**LOCAL HISTORIC DISTRICT:** Dilworth

**ADDRESS OF PROPERTY:** 323 Rennselaer Avenue

**SUMMARY OF REQUEST:** Addition/Garage

# Charlotte Historic District Commission - Case 2013-192

Front Elevation

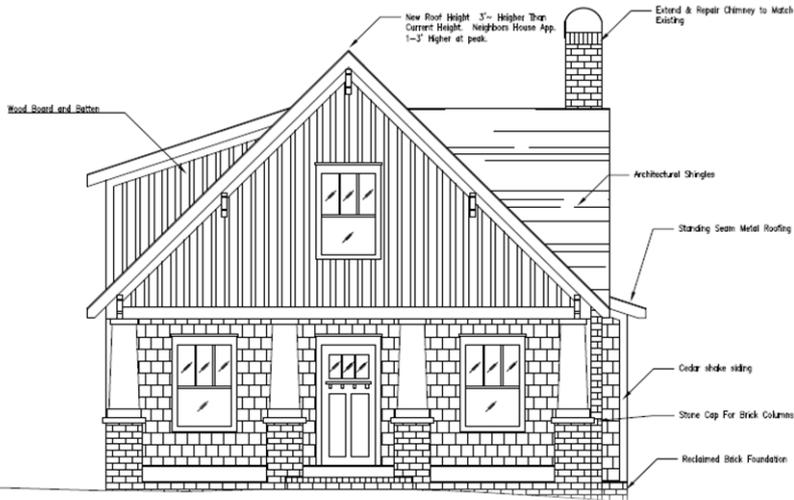
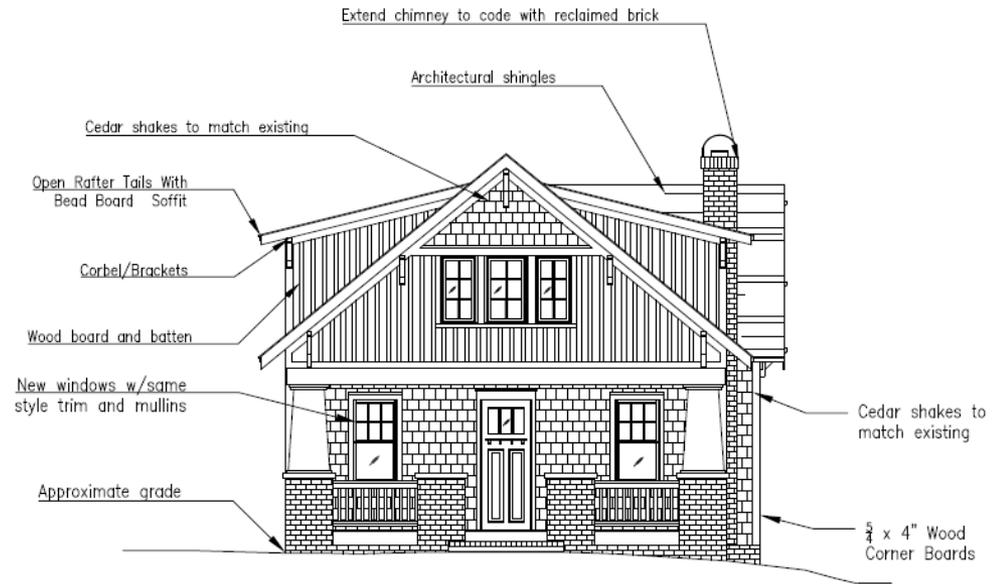
1. Overall height has been reduced
2. Front gable roof pitch lowered
3. Additional detail to top gable with cedar shakes
4. Revised window pattern in front gable and throughout
5. Removed middle columns on porch and redesigned end columns and posts
6. Added railing to front porch
7. Shifted right shed dormer to front
8. Added windows to either side of chimney
9. Moved side gable to rear with revised window pattern
10. Reduced height of left shed dormers and widened
11. Evened window pattern on lower level
12. Revised window pattern on rear elevation
13. Added top gable detail

Based on the changes in response to Commission concerns from September, staff believes this project has met the Substantial Change criteria.
